**Sent:** 24/02/2020 12:20:15 PM  
**Subject:** Submission re DA2020/0108 - 837 Pittwater Rd Collaroy  
**Attachments:** submission re #837 granny flat to NB Council.docx; Stephanie Graham - NSW Plan - Deposited Plan 1010026.pdf;

## Submission re DA2020/0108 – 837 Pittwater Rd Collaroy

DP1010026

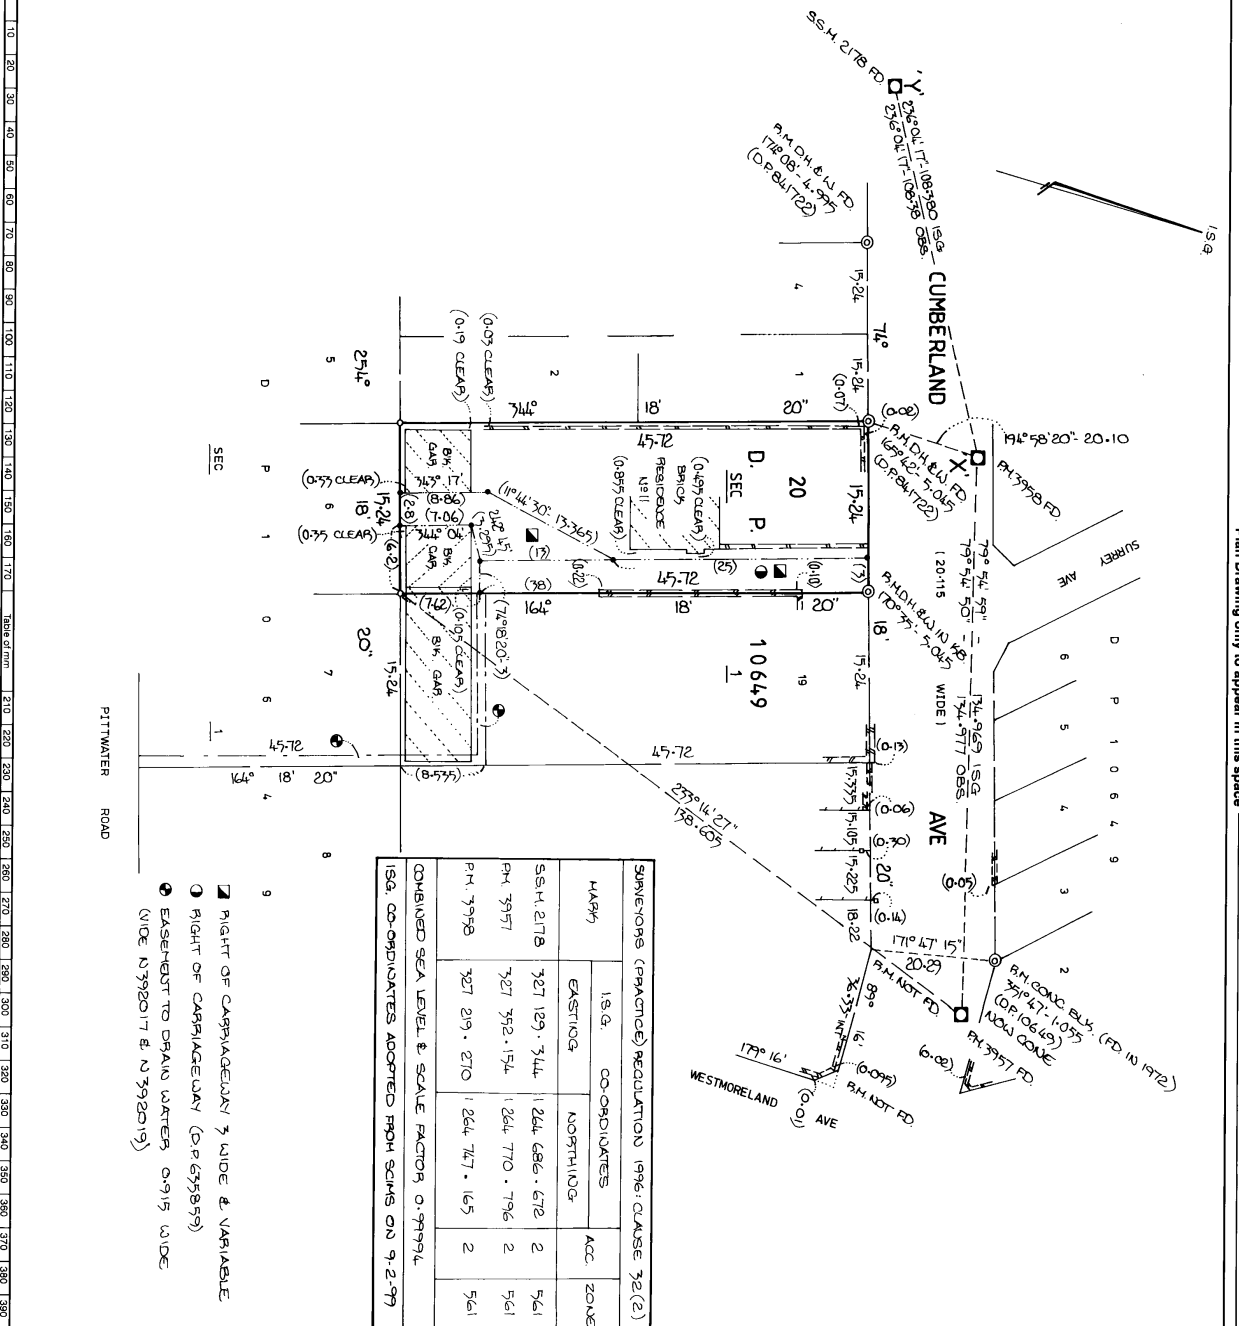
1. **The Site Management Plan** shows a solid line across the rear boundary ie it does not show DP 1010026 which is the ROW from #11 down the ramp into #837. We would like to know if this DP is still in use and will be used during and after the building of the proposed granny flat and we would like to know if DP1010026 should have been included on the DA for the granny flat.
